ADDENDUM NO. 4

FIRE STATION NO 6 GEORGETOWN, TEXAS

DATE: December 14, 2018
PROJECT NO: 217079.00.00

The Construction Documents on the above referenced project, dated 11/16/2017, shall be revised as follows:

On-Site Wastewater Disposal System

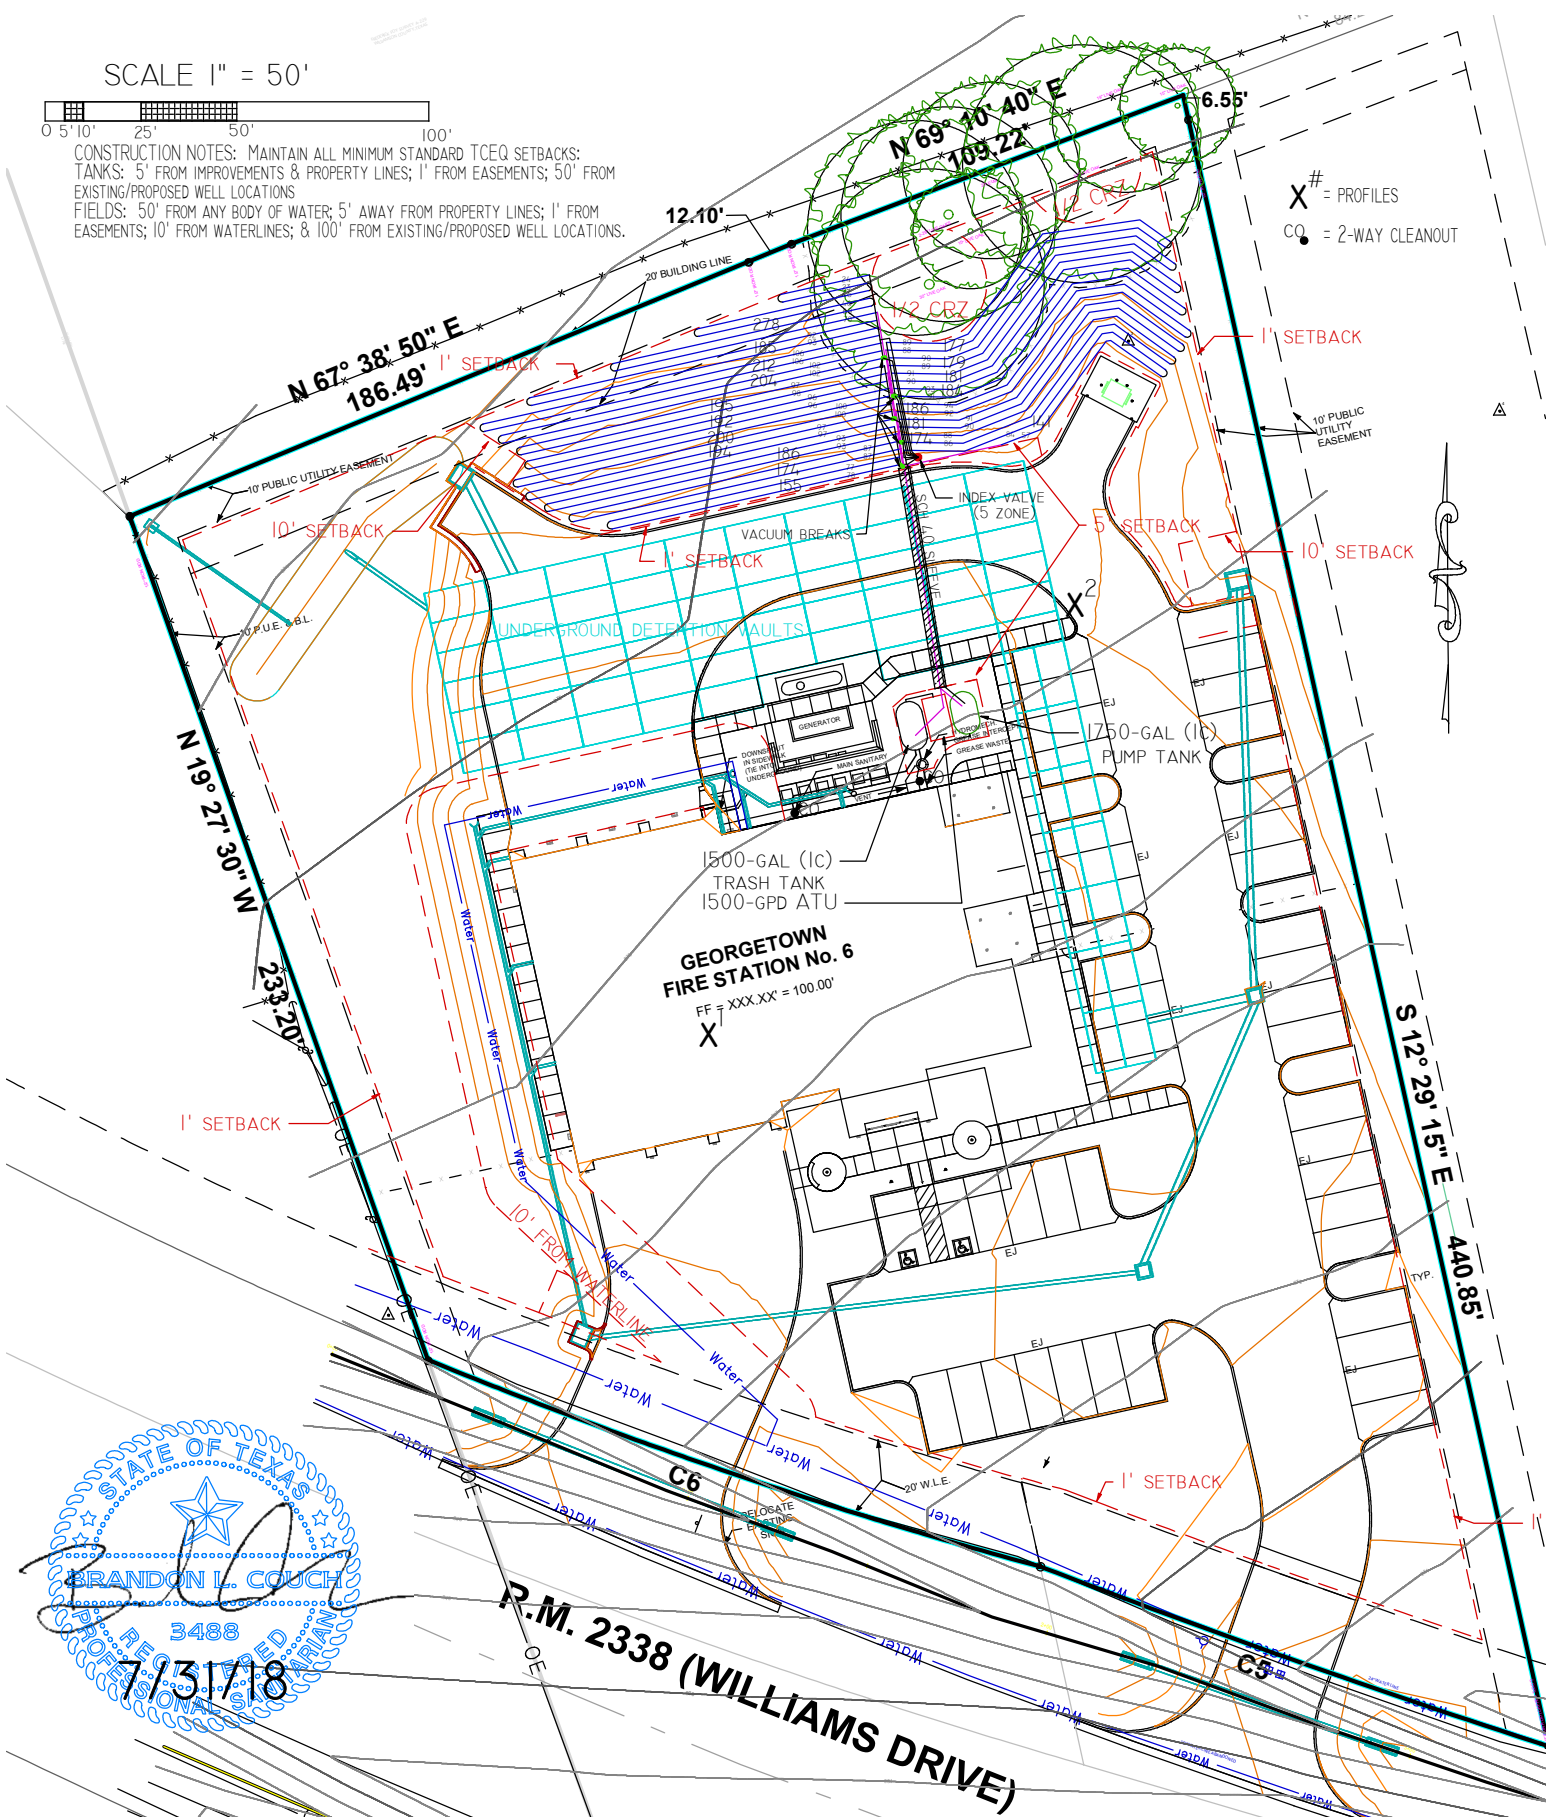
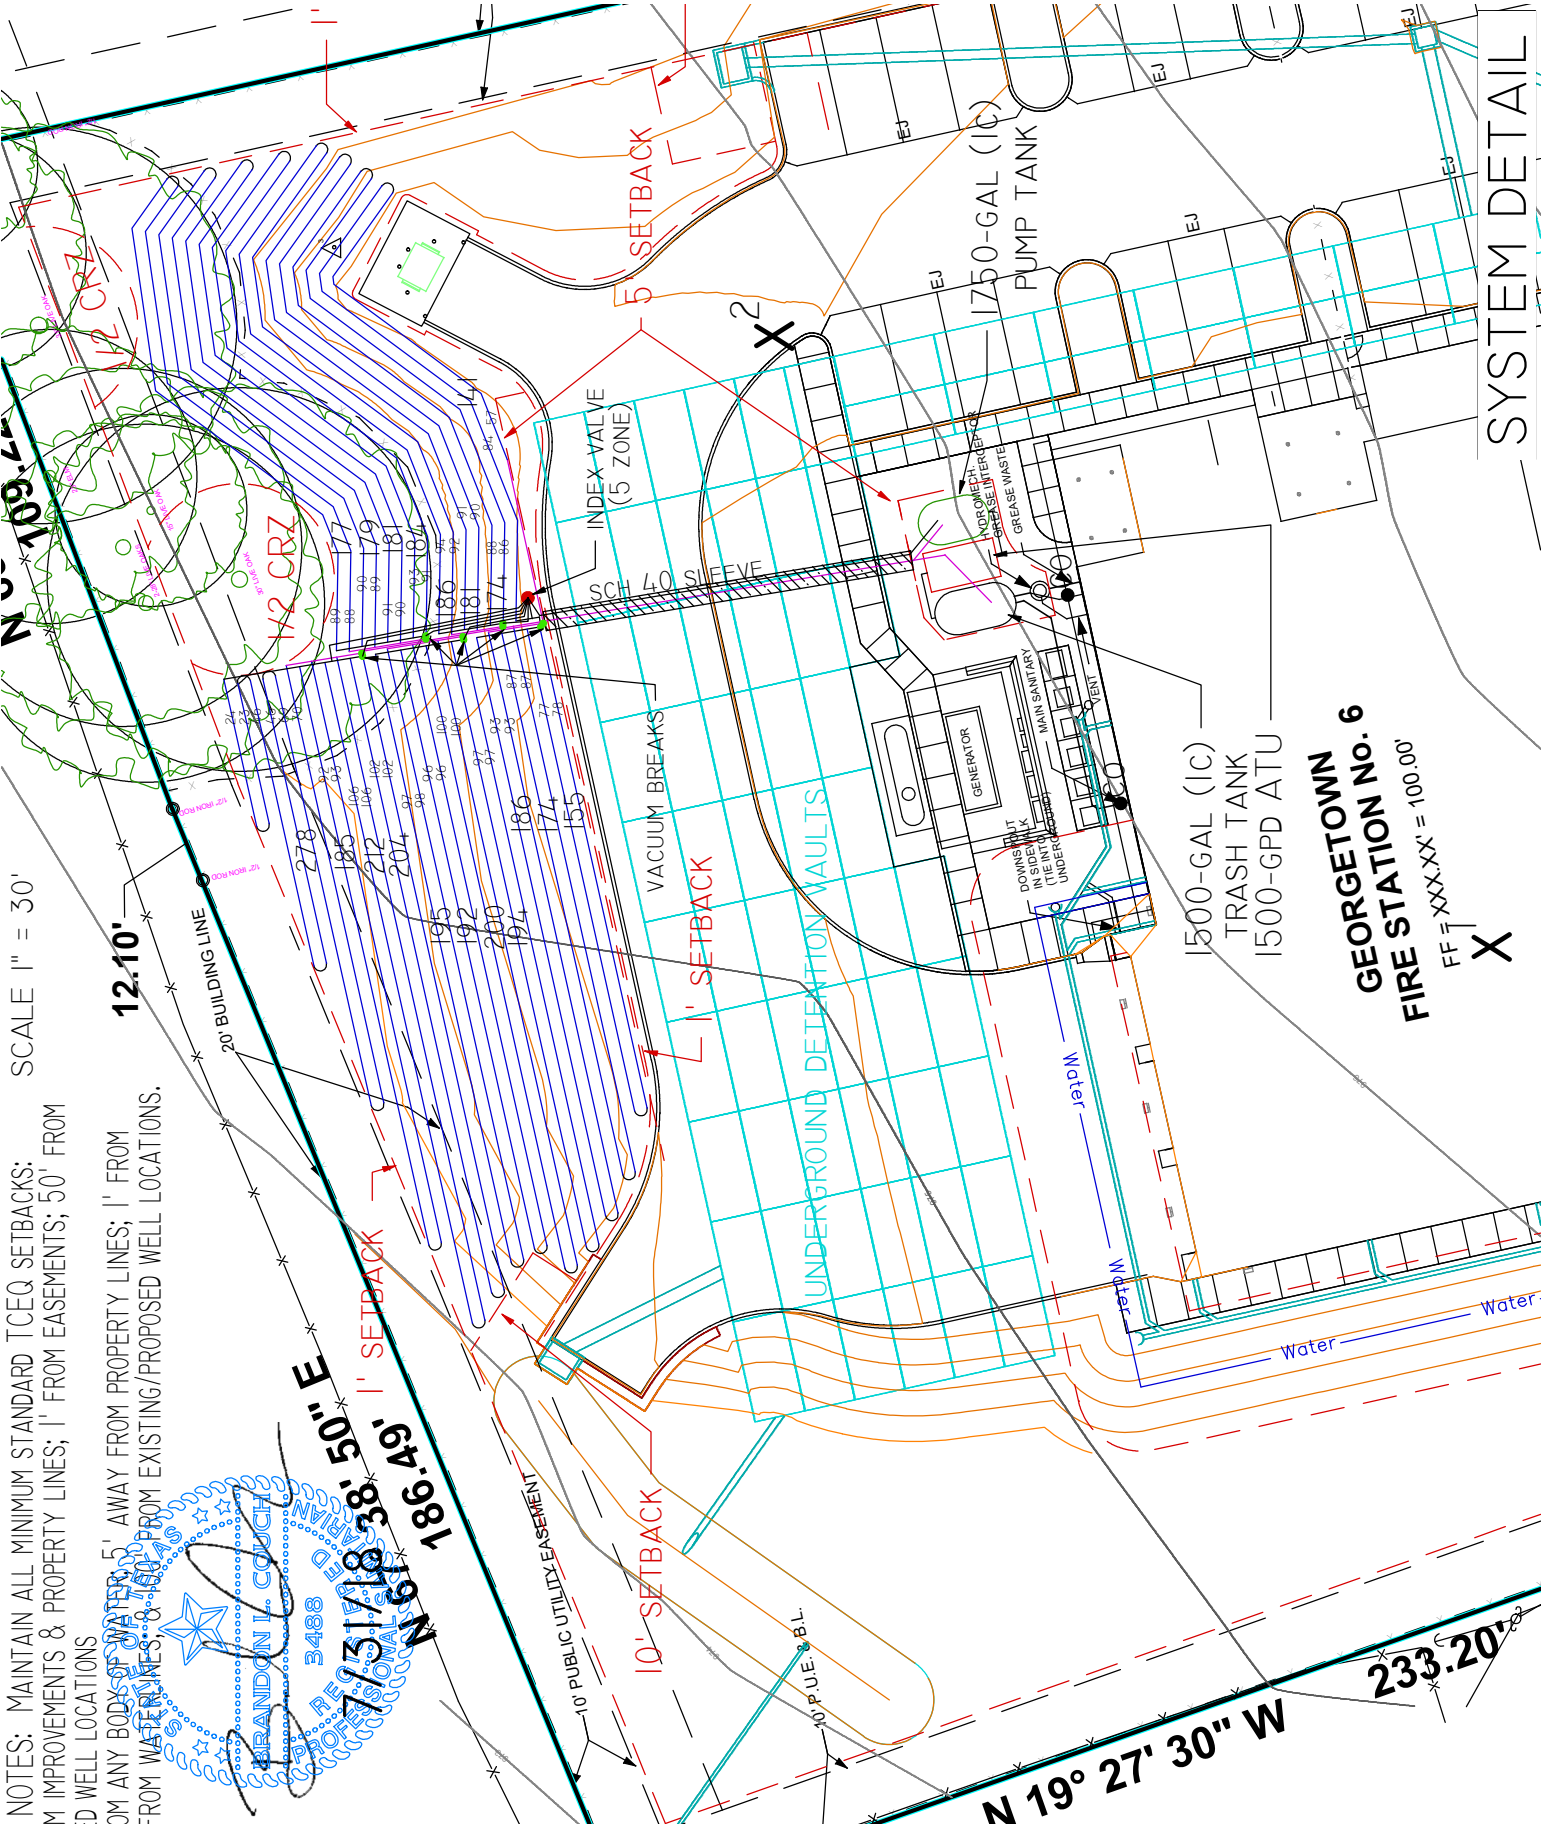
Item No. 4 (Drawing Sheet C3.0) Site Utility Plan: Sanitary System. All Sanitary Sewer Lines from the building are connecting directly to the Onsite Sanitary Sewage System design by Brandon Couch. See Attached **On-Site Wastewater Disposal System**.
